1 **SETTLEMENT RESPONSES TO CONSUMERS COUNCIL OF CANADA**

3 **SC-CCC-1**

Figure 2 - 28kV Forecast - Subset of Stations¹¹

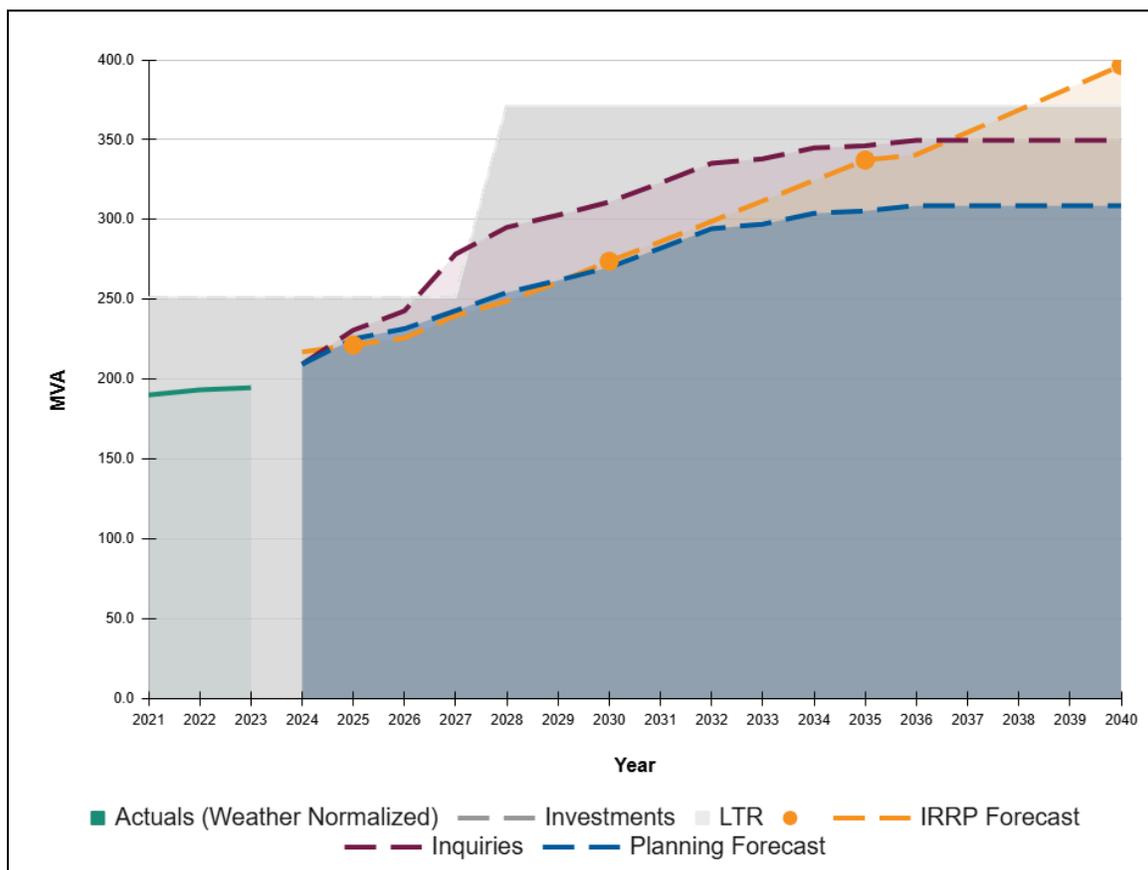
23
24 Figure 2 within Attachment 2-Staff-67(A) - NWCSP - BCA Summary Report illustrates the
25 potential need for a second station within the region around 2037 (IRRP Forecast) in absence of
26 any capacity benefits resulting from the NWCSP.
